**IN THE MATTER OF** Resource Management Act 1991

**IN THE MATTER OF** Proposed Plan Change 14 Housing and  
Business Choice pursuant to Part 5, subpart  
5A and Part 6 of Schedule 1 of the Resource  
Management Act 1991

**ADDENDUM 2 TO PART 5 OF RECOMMENDATIONS REPORT IN RELATION TO  
BELFAST COMMERCIAL CENTRE AND STYX RIVER SETBACK QUALIFYING MATTER  
AND RICCARTON BUSH INTERFACE AREA QUALIFYING MATTER**

## As Notified

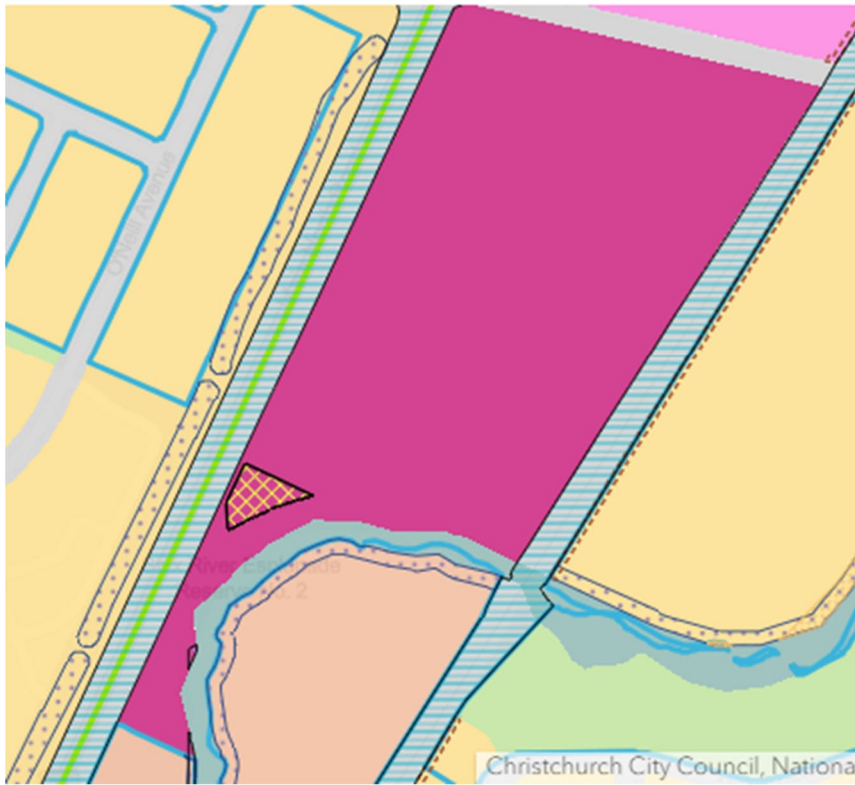
15.4.3.2.8 – Maximum threshold for non-residential activities (delete)	<ul style="list-style-type: none"> <li>Do not relocate this rule as the provision relates to 'non-residential activities' which is not relevant to the HRZ</li> </ul>
Appendix 15.15.1 (delete)	<ul style="list-style-type: none"> <li>Relocate Appendix 15.15.1 to be Appendix 14.16.12</li> <li>Amend the heading of new Appendix 14.16.12 to read as follows: 'Residential High Zone (Belfast Northwood) Outline Development Plan'</li> </ul>
<b>Planning Map</b>	
The zoning of 20 Radcliffe Road, Belfast was shown as Town Centre and the Styx River Setback QM was shown as a triangle shape with cross hatching on the Planning Map accompanying PC 14 as shown below:

The Council is to review and confirm that the mapping of the Styx River Setback QM is correct.

## Council Reply

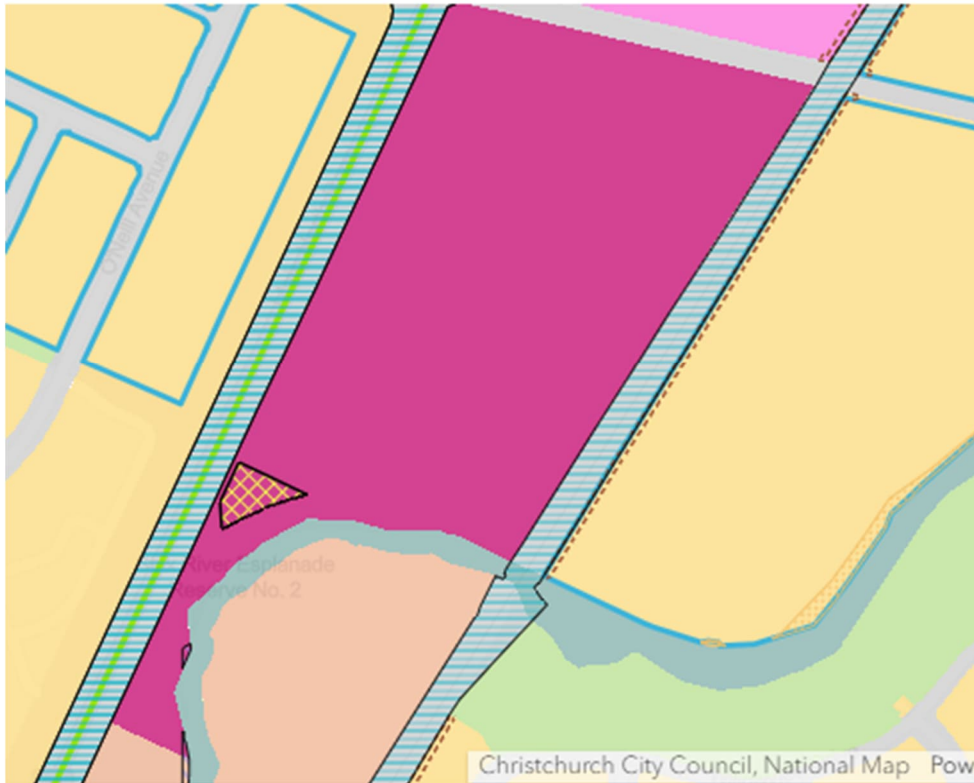
In the Council Reply version of the Planning Map the zone and QM was shown as follows:

These areas are a different and larger shape and are located in a different location.
